CABINET MEMBER FOR ENVIRONMENT – 19 DECEMBER 2019
ARDLEY: B430 STATION ROAD – PROPOSED PUFFIN CROSSING

3. This report presents responses received to a statutory consultation to introduce a puffin crossing on the B430 Station Road.

DRAWING FILE: S278 WORKS

SHEET NO.	SCALE	DATE	ORIGIN	DESIGNED	DRAWN
A1	AS SHOWN	DEC 2017	WJD	CCE	-
7397	DRAWING NO.	104	REV	P1

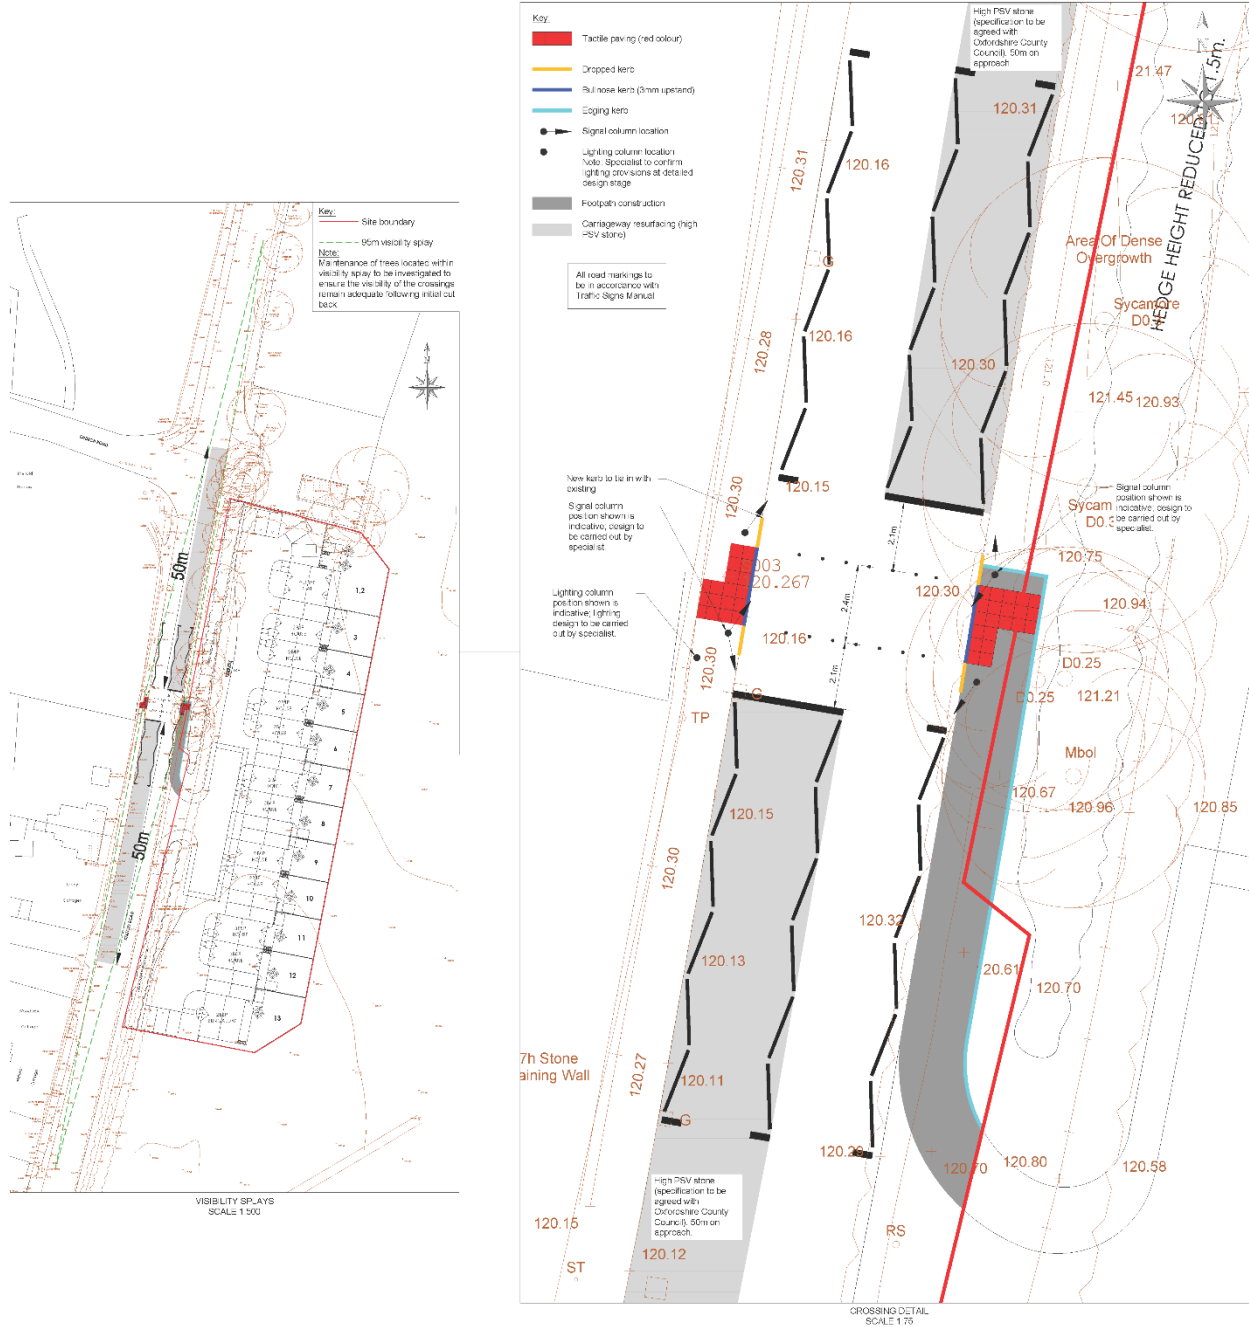
7. Thames Valley Police did not object to the proposal.
8. Ardley with Fewcott Parish Council support the proposal, noting that their preferred option of providing a pedestrian link on the east side of the B430 Station Road northwards to tie in with the existing footway and signalled crossing (thereby avoiding the need for the proposed crossing) was found not to be viable.

9. Two objections were received from members of the public, both local residents, citing concerns over the proximity of the proposed crossing to the existing signalled crossing approximately 75 metres to the north; the adverse visual impact of the proposed crossing and associated street lighting very close to the church; noise associated with lorries braking for the crossing; the limited use of the crossing given the relatively small scale of development (17 houses) and also safety taking account of the speed of traffic with the current 40mph speed limit in place. These responses also requested consideration of measures to avoid the need for the crossing including construction of a pedestrian link on the east side of the road northwards to connect to the existing footway and signalled crossing and a 30mph speed limit enforced by speed cameras and if these were not viable, measures to mitigate the impact of the crossing, including provision of street lighting minimising light pollution and crossing equipment and lighting that only switches on when pedestrians approach to use it.

(3) Local Resident, (Ardley)	<p>Object - There is already a crossing within 200m of the proposed site, together with four lighting posts which runs 24 hours a day. To construct two crossing this close, with the addition of further lighting posts will affect the environment in which we live in two ways.</p> <ol style="list-style-type: none"> 1. By creating further light pollution. 2. By surrounding our ancient church with two sets of crossings, traffic lights and street lighting. <p>I would hope that this substantial work would be unnecessary given the small number of houses it will support - and I do speak as someone who occasionally uses the current crossing. It is worth noting that the requirement to use the present crossing is greatly diminished due to the Fox and Hounds Pub no longer trading - which was one of the primary reasons for building it.</p> <p>I do however understand the need for safe crossing and would ask that the following be taken into consideration.</p> <ol style="list-style-type: none"> 1. Would it be possible to construct the new crossing with a sensor which turns on the lights when the crossing is approached by a pedestrian? This seems to be in place in many other rural areas we visit and reduces the energy costs and light pollution. 2. If streetlights have to be constructed could they please be the low light pollution versions we can see used in Bicester, rather than the very bright light pollution versions we currently have.

<p>3. Could the speed limit be reduced to 30mph? It seems unusual to have two crossings serving 17 houses in 200 metres and on a 40mph road. If it was 30mph could a lower cost alternative crossing be used?</p>
<p>(4) Local Resident, (Ardley)</p>	<p>Object – The reasons for our objection are below:</p> <ul style="list-style-type: none"> - The new crossing will be within 60 metres of the current pedestrian crossing outside The Fox and Hounds Pub. Surely having 2 crossings so close together will look very unsightly and cause a very cluttered landscape. - We don't believe the crossing will have adequate use to justify its place. Although we understand that the new housing development has some affordable properties within it, the residents will be unlikely to choose to live somewhere like Ardley unless they have a car. The village doesn't have lots of amenities and any that are available could be driven to. - If the residents were on foot/bicycle it would make much more sense for them to use the current crossing. As there is currently no footpath to this crossing on the main road, could a cycle/footpath not be created that runs behind the development and joins up to where the path starts for the current crossing? - The road is a main road and traffic travels very fast (much faster than the 40mph set speed limit) so it's not a nice road to walk along. - As a resident living on the road it is already difficult to turn onto and off of. Adding another complication to this will only cause it to be more problematic. - As cars do not adhere to the current speed limit (as we have stressed multiple times already) the new proposed splay for the crossing may not be long enough. Vehicles travelling at 50mph require a minimum of 85m to stop in wet conditions so if the crossing is not seen immediately, they may not physically be able to stop in time. - Lorries having to brake for an additional crossing will add to the traffic noise pollution. The B430 can at times be a very busy road which may make it tricky to cross, however the real problem is when it's not busy as that it when drivers are likely to be driving through the village way above the current speed limit of 40mph. If the speed limit was changed to 30mph and this was enforced with a speed camera, the new residents would be able to safely cross the road as in any other village or town. We are aware that this idea has previously been rejected by the council and that they are not keen to amend the speed limit until a fatality has occurred, but to us this seems like the most obvious solution. Adding more pedestrians walking along and vehicles turning on and off of the road with its current regular

speeding visitors is quite frankly an accident waiting to happen. This would be our preference as it would also lessen the road noise and be less disruptive at busy periods than an additional crossing as during these times there are often queues anyway so it would not add to people's travel times.
(5) Resident, (Abingdon)	Support – <i>No comments.</i>

10. Noting the above concerns, the scope for providing a pedestrian link on the east side of the B430 to tie into the existing pedestrian provision was exhaustively explored as part of the planning approval process but found not to be viable. Given that it is essential that occupants of the new residential development have a safe and convenient means of accessing the village on foot, a signalled crossing is considered the only viable means of achieving this. While not ruling out consideration of reducing the speed limit to 30mph at some point in the future, this would not achieve the required level of safety in the absence of a crossing. The signals and street lighting will be designed to minimise environmental impact while acknowledging that they must nevertheless be designed to the appropriate standards and also noting that it is not feasible at present to install equipment that only switches on when pedestrians wish to cross.
